Commonwealth Edison
 One First National Plaza, Chicago, Illinois
 Address Reply to: Post Office Box 767
 Chicago, Illinois 60690

Subject: Proposed Change of the Maximum Allowable In-Sequence Control Rod Worth Permitted by the Technical Specifications for Dresden Unit 3, AEC Dkt 50-249

TECHNICAL BASIS FOR CHANGES TO
ALLOWABLE ROD WORTH SPECIFIED

TECHNICAL SPECIFICATION 3.3.B.3 (a)

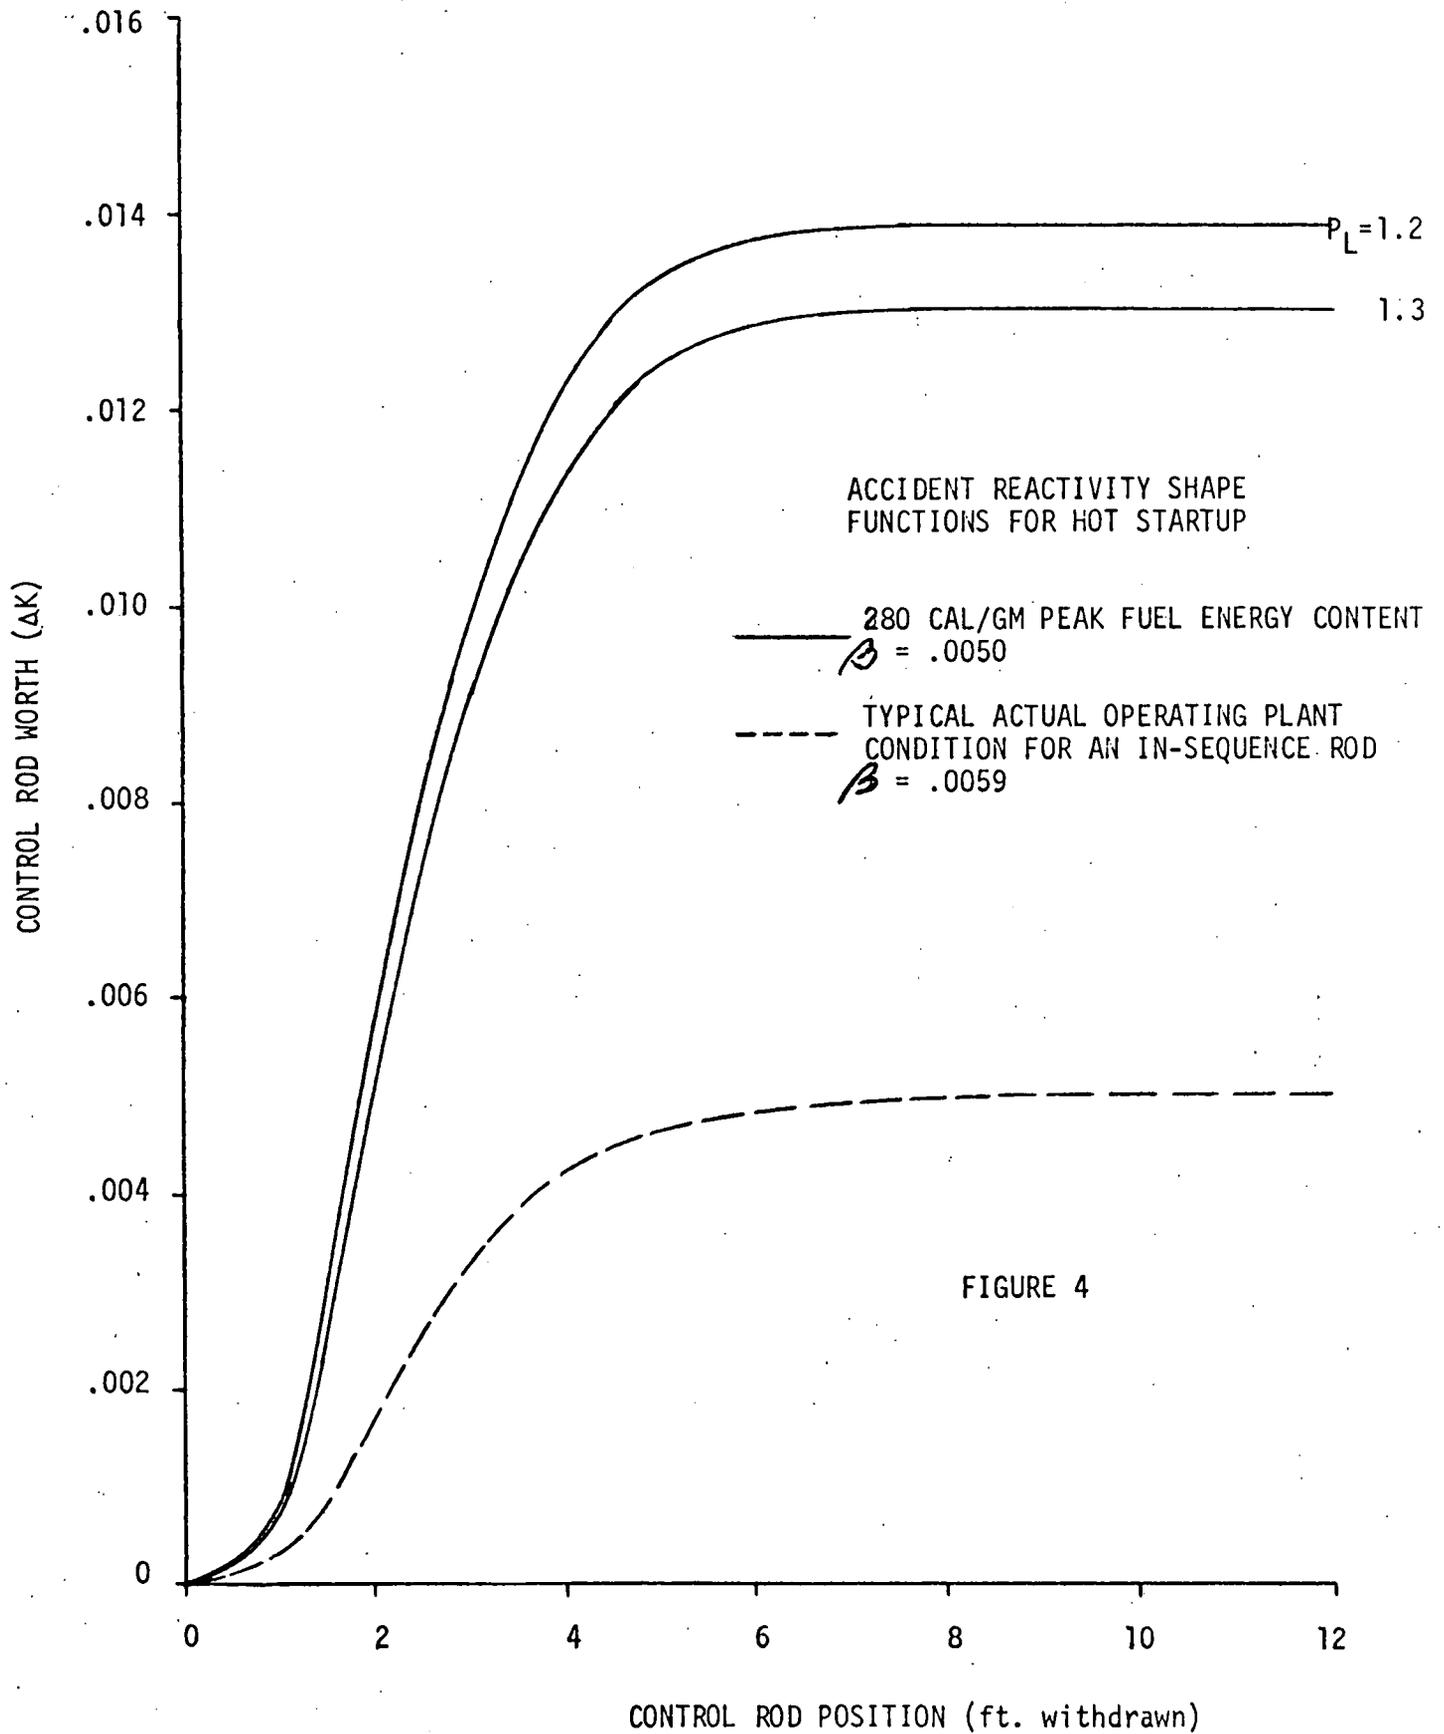
The sensitivity of the rod drop accident to the first three parameters at cold startup and hot startup are shown by Figures 1 and 2 and the effect of the delayed neutron fraction (β) can be seen by comparing Figures 1 and 2 with Figures 3 and 4 respectively. To determine whether or not a specific condition will meet the 280 cal./gm design limit at cold startup or hot startup, the accident reactivity characteristics (i.e., accident shape function, local peaking, etc.) for the plant being analyzed should be matched to those presented in Figures 1 through 5. If the accident reactivity characteristic curves are equal to or less than those shown as solid lines in Figures 1 through 4, then one of the three conditions needed to conservatively ensure RDA peak fuel enthalpy equal to or less than 280 cal/gm is satisfied. If the actual plant accident reactivity characteristics are greater, a more detailed analysis would have to be performed.

Some example curves resulting from calculations with operating plant data are also plotted as dotted lines on Figures 3 and 4 to demonstrate compliance with the condition, including the

one with the highest k_{eff} . Other data (not plotted to avoid confusion) are shown in Table 1. Comparisons have been made on Figures 3 and 4 because the betas most closely coincide. The beta for Figures 1 and 2 correspond to Beginning-of-Life (BOL) conditions which no longer exist for operating plants.

Although the betas associated with the operating plant curves are not precisely the same as the value used for the 280 cal/gm boundary curves, the differences are in the conservative direction.

As shown in Table I, betas for operating plant conditions are generally higher than those used in Figures 3 and 4 for the 280 cal/gm boundary curves, thus allowing higher $P_{L's}$ or rod worths within the boundary.

Figure 5. Doppler Reactivity Coefficient vs Average Fuel Temperature as a Function of Exposure and Moderator Condition

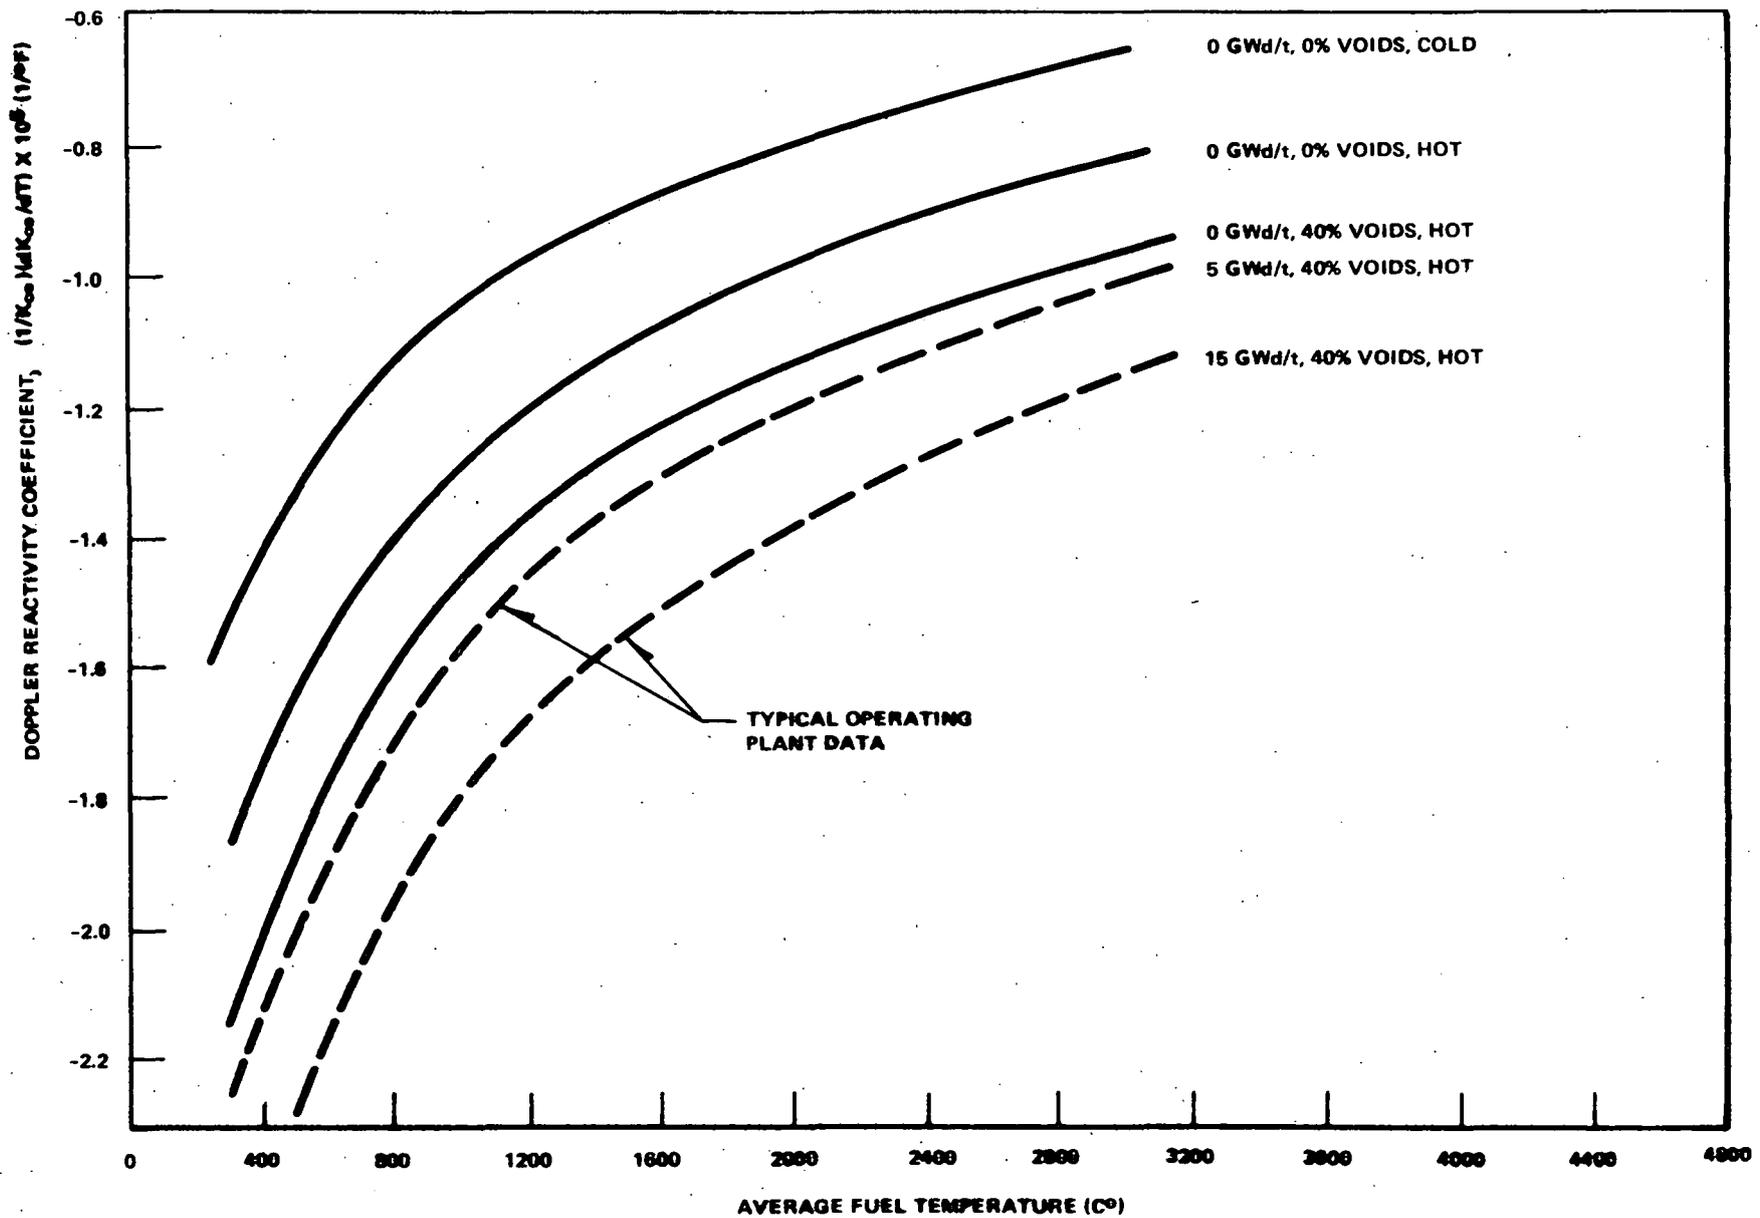
The Doppler reactivity coefficients used for these analyses to identify a 280 cal/gm boundary were held fixed at the beginning of life (BOL) condition. The Doppler reactivity coefficients for the cold and hot startup conditions are presented in Figure 5.

If the Doppler reactivity coefficients are equal to or more negative than those given as solid lines in Figure 5, then another one of the three conditions needed to conservatively ensure RDA peak fuel enthalpy ≤ 280 cal/gm is satisfied.

Using the BOL Doppler reactivity coefficient will be conservative since the Doppler coefficient always becomes more negative with increasing exposure. This effect is typically demonstrated by the exposed core data shown as dotted lines on Figure 5, and is due primarily to the Pu-240 buildup as a function of exposure.

FIGURE 6

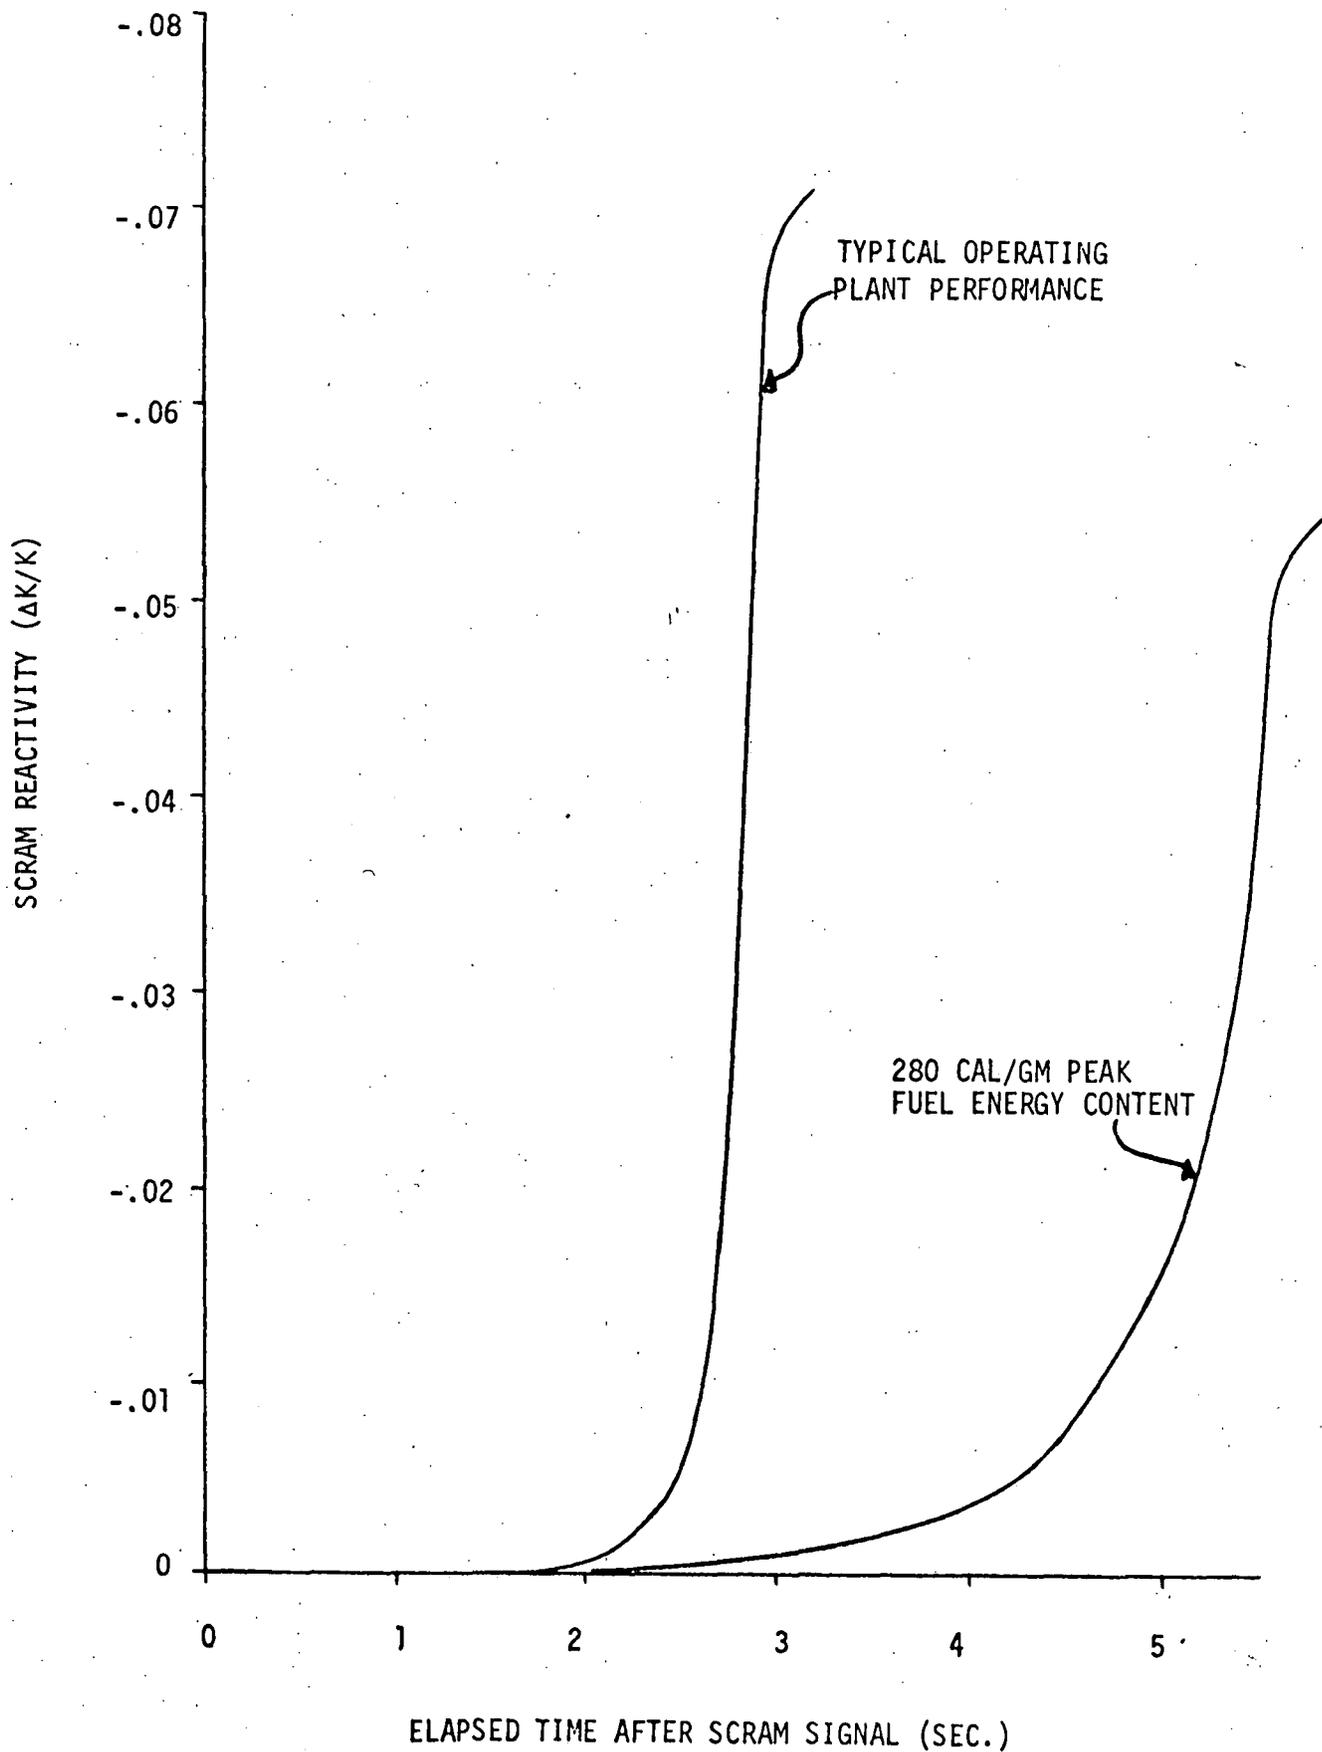
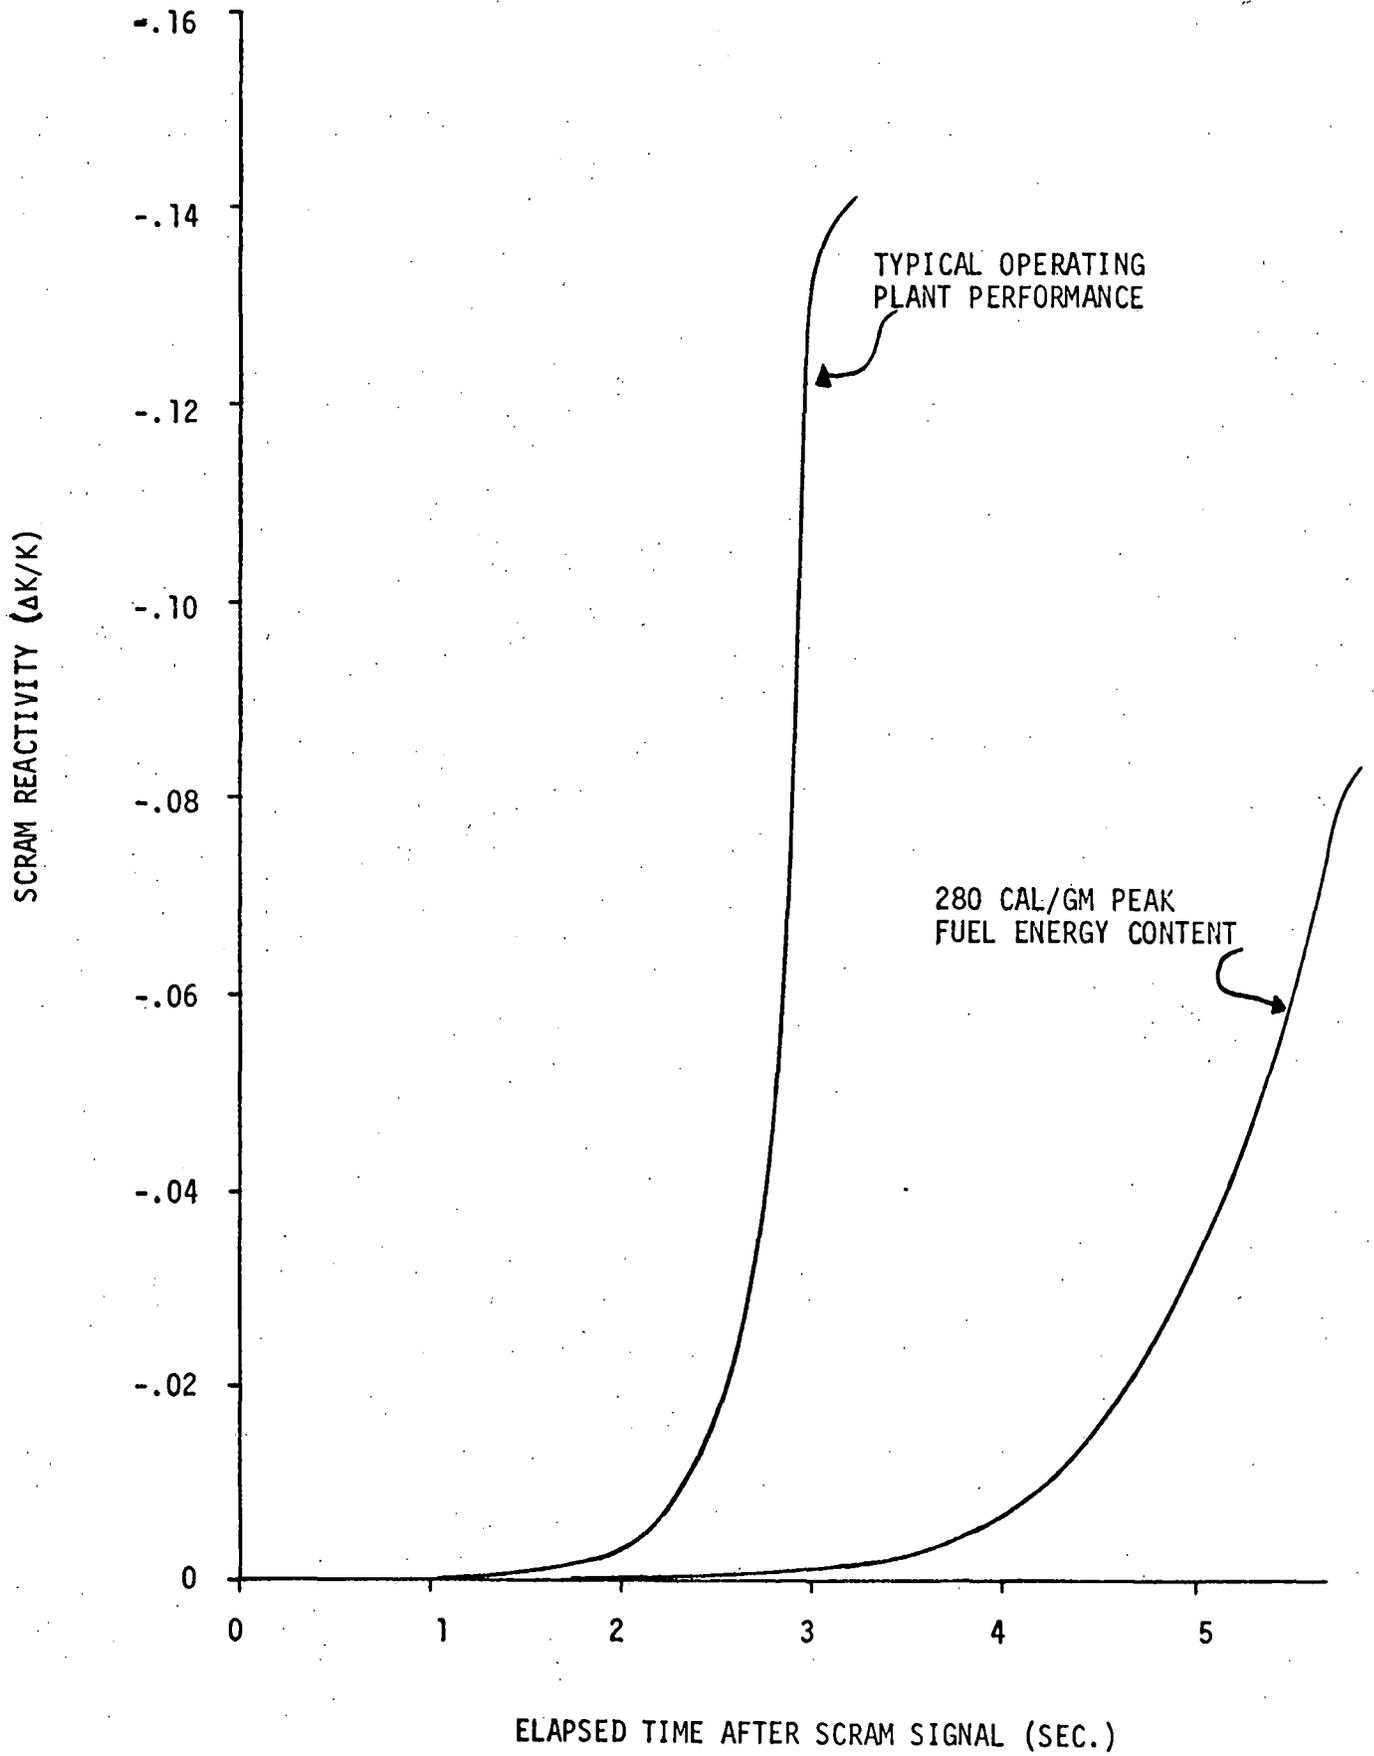
A typical example derived from operating plant data is also plotted on these figures as dotted lines to demonstrate that the condition is met in actual scram performance. Additional available data was not plotted to avoid graphic confusion, but is summarized with total scram worths in Table I.

1. Scram reactivity condition: While there could be significant variation in the shape and total worth of the scram reactivity curve, actual operation in the future is not likely to degrade down to the point where the net effect on a RDA would be any less than that represented by the 280 cal./gm curves of Figures 6 and 7.
